# ZAYO'S PRINEVILLE TO RENO PROJECT

## CPUC MINOR PROJECT REFINEMENT FORM

**RFI 321-325**

**AK - ALTURAS TO JUMPER RIDGE RD**

SHEET NO.: 41 of 75

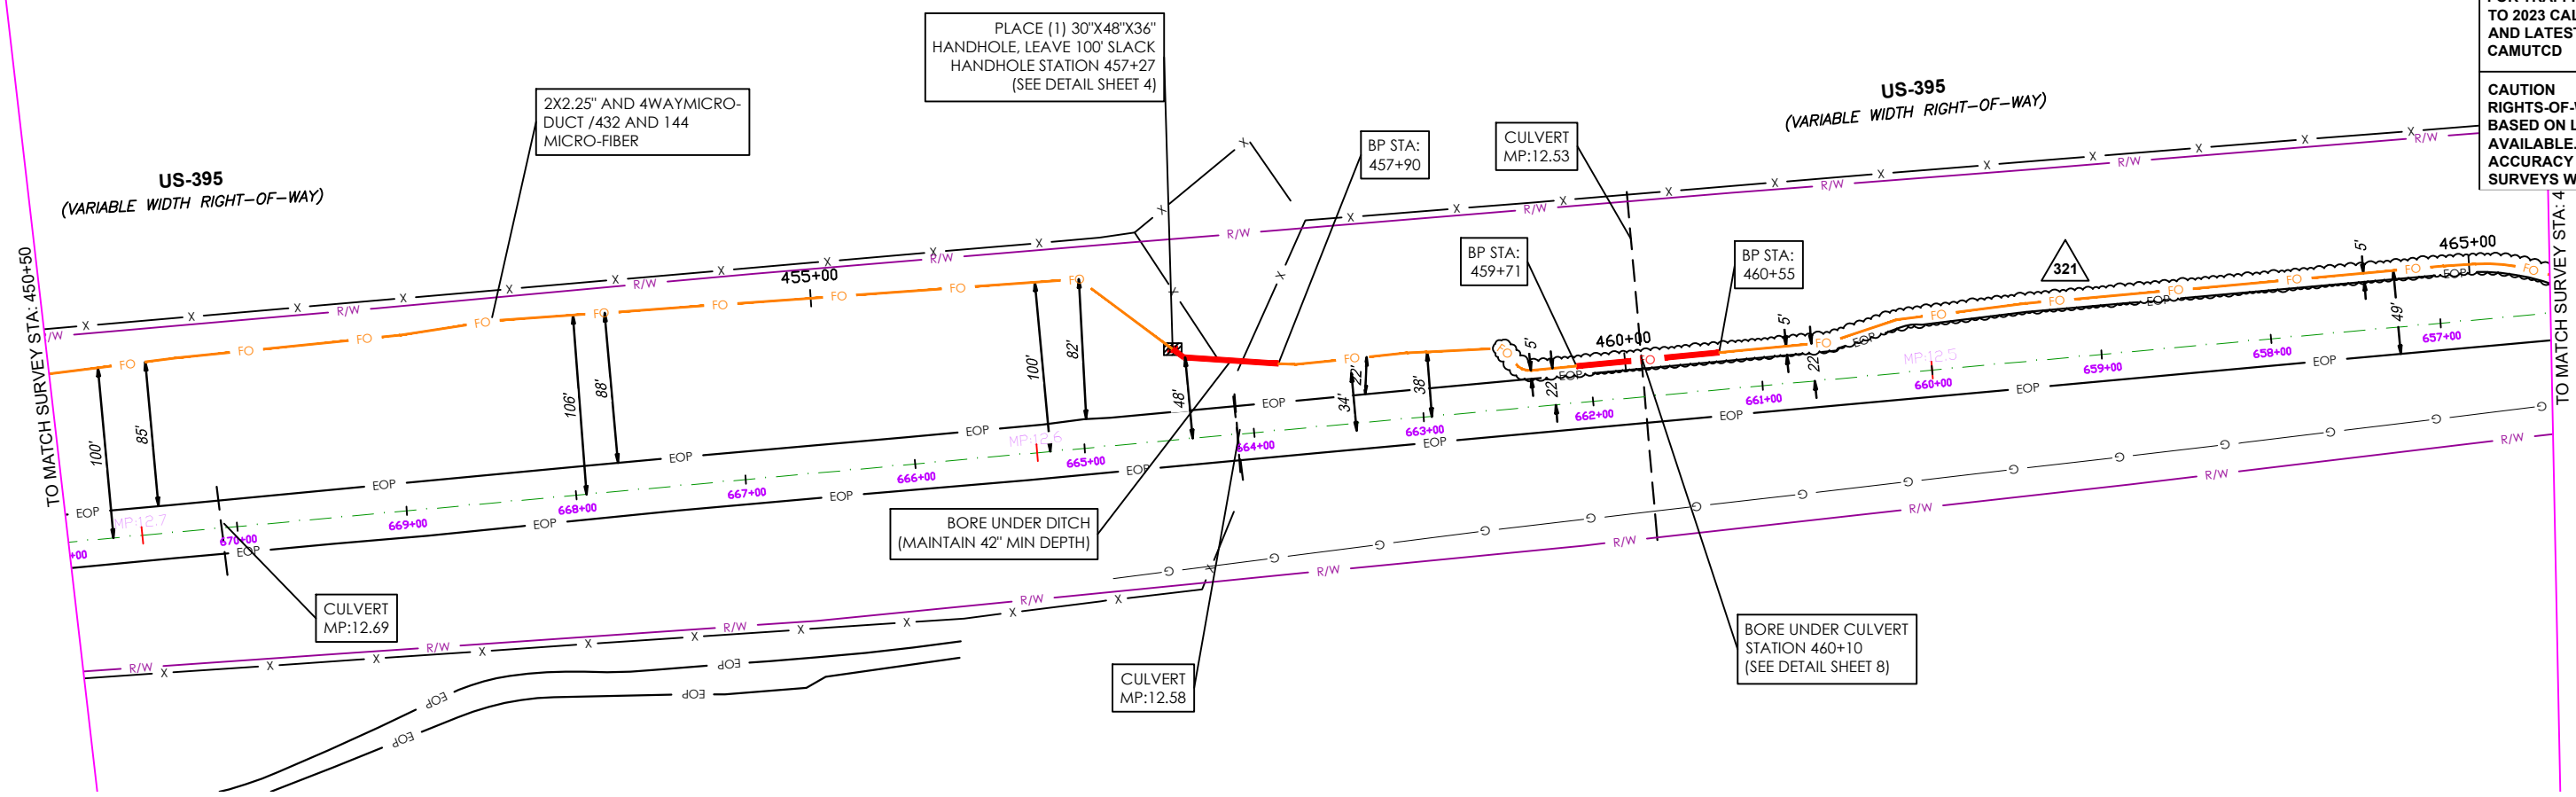
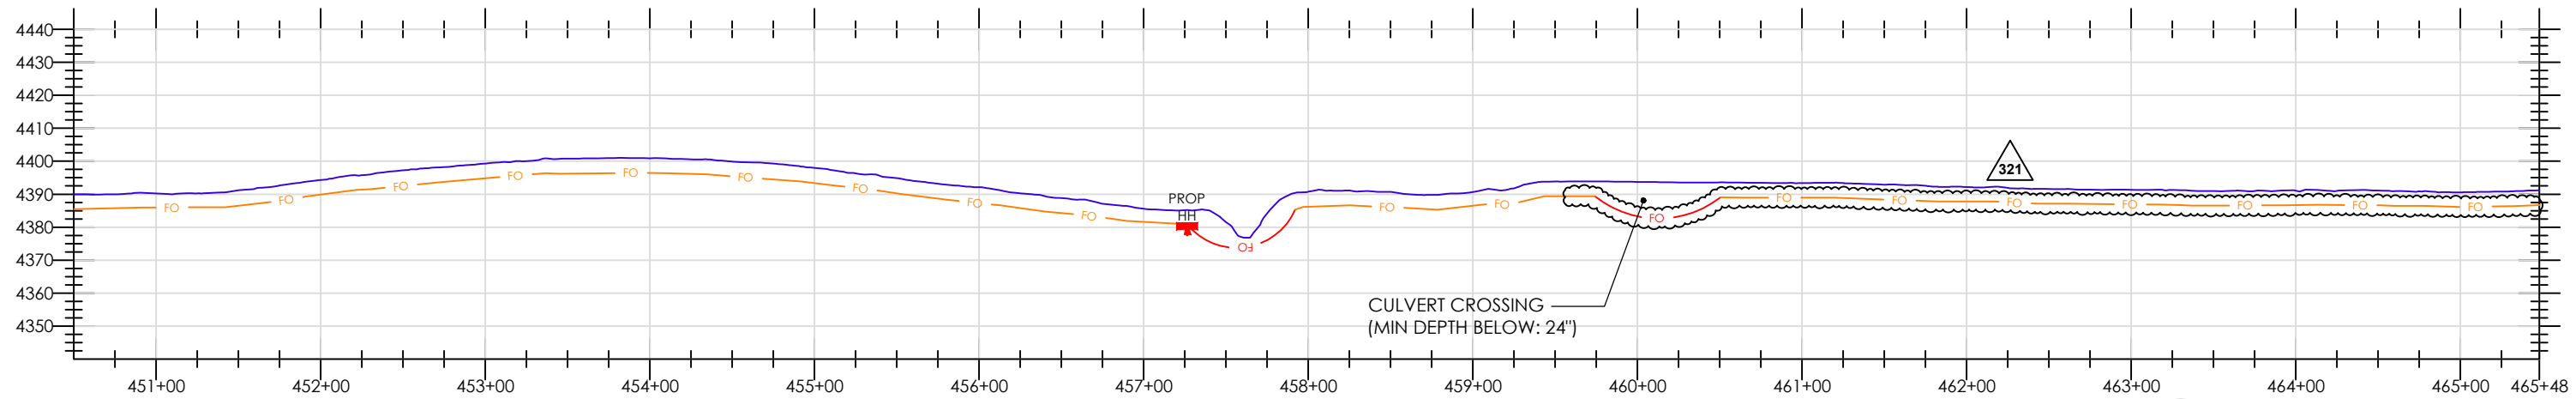
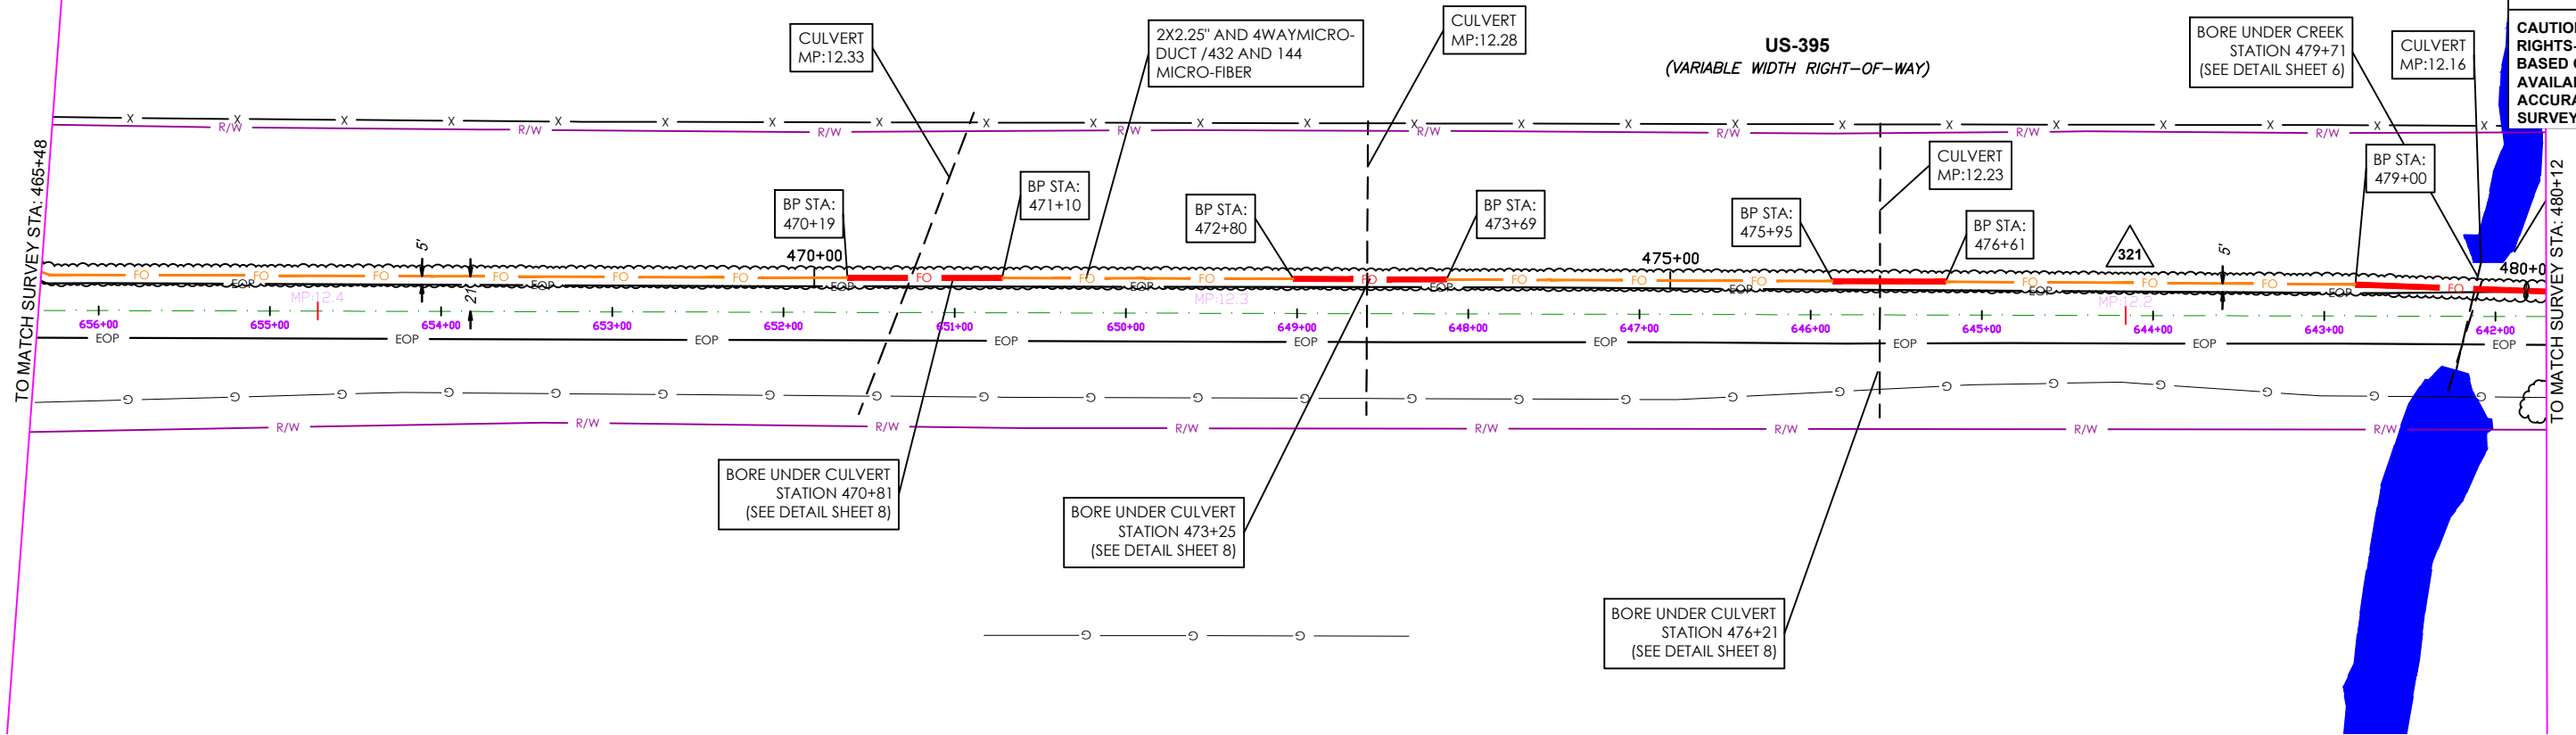
RFI NO. 0321 SHIFT R/L TO 5 FEET OF EOP STA 459+24 TO STA 480+00	10/09/2024

- Maintenance – No change to maintenance
- Design – Design is consistent with approved plans, just on the opposite side of the road
- Environmental – Increased distance from running line to existing wetland will provide greater buffer

SHEET NO.: 42 of 75

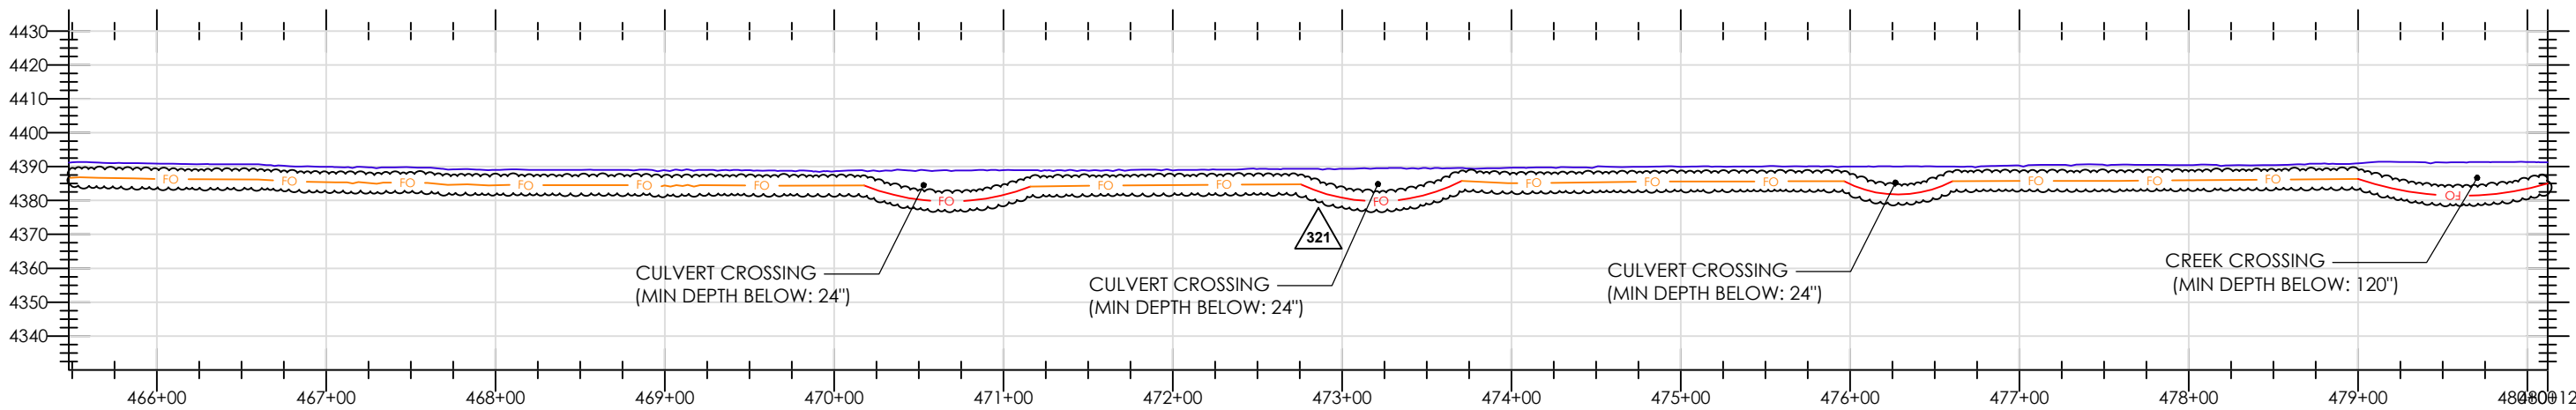
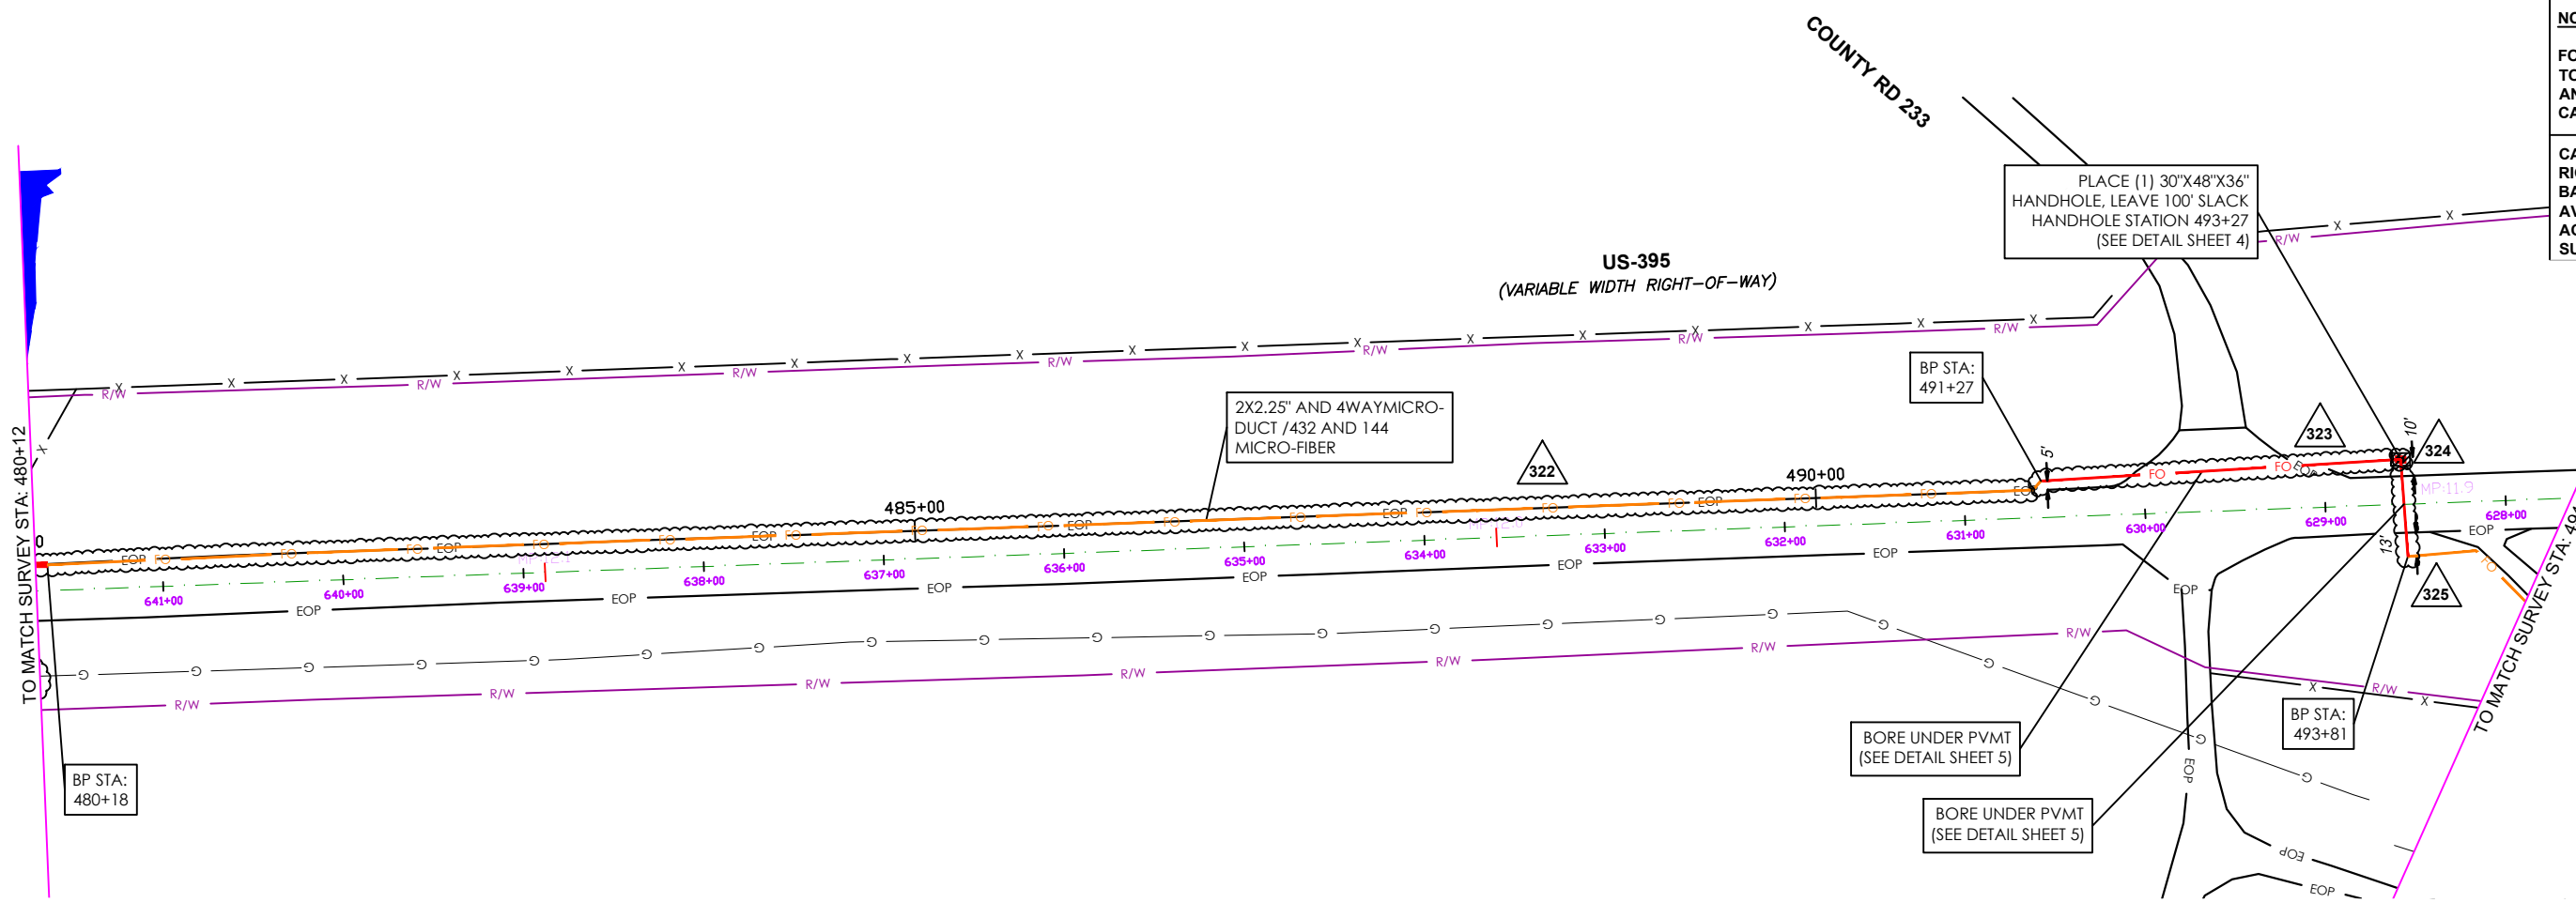
RFI NO. 0321 SHIFT R/L TO 5 FEET OF EOP STA 459+24 TO STA 480+00	10/09/2024

SHEET NO.: 43 of 75

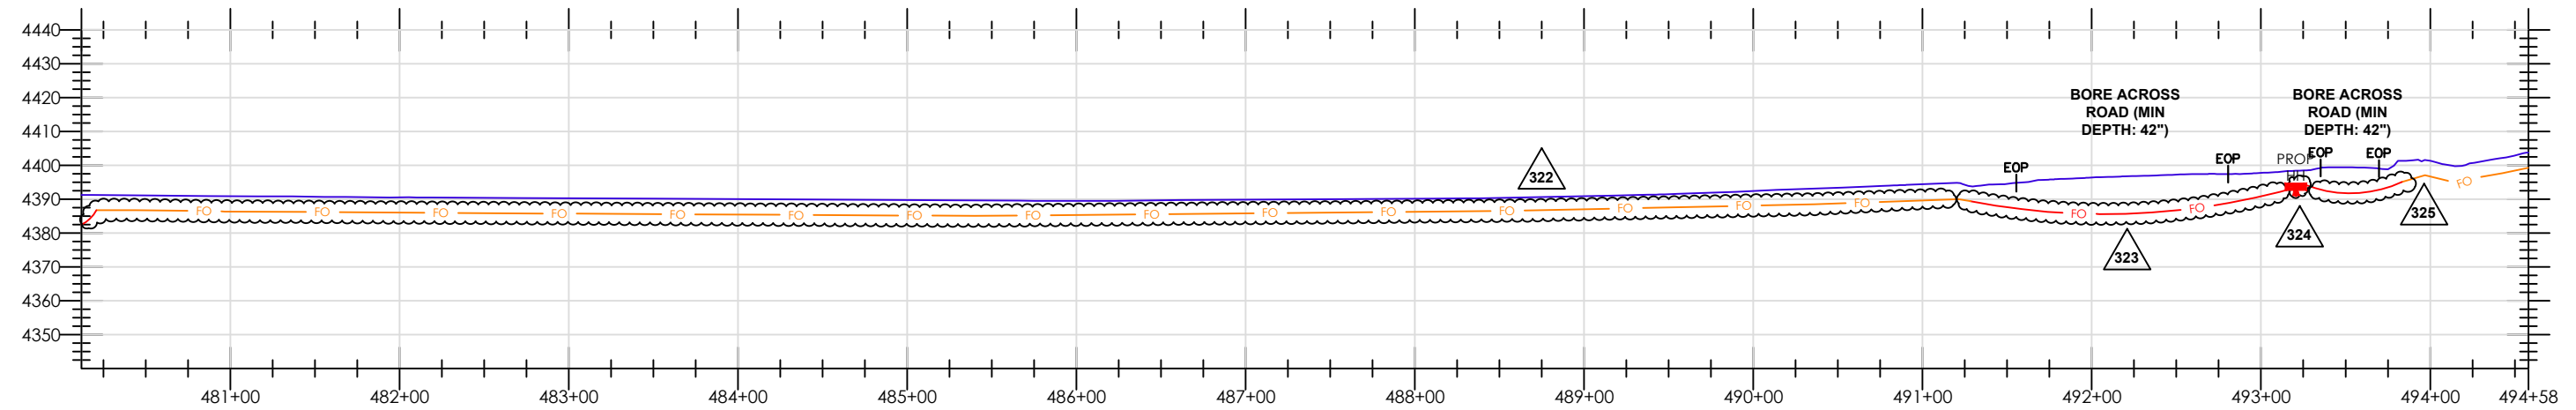
RFI NO. 0322 SHIFT R/L TO EOP STA 480+00 TO 492+00	10/09/2024
RFI NO. 0323 BORE 5 FT & 10 FT O/S EOP STA 492+00 TO STA 494+00	10/09/2024
RFI NO. 0324 MOVE HH TO SOUTH BORE PIT STA 494+00	10/09/2024
RFI NO. 0325 BORE FROM EAST TO WEST STA 494+00	10/09/2024
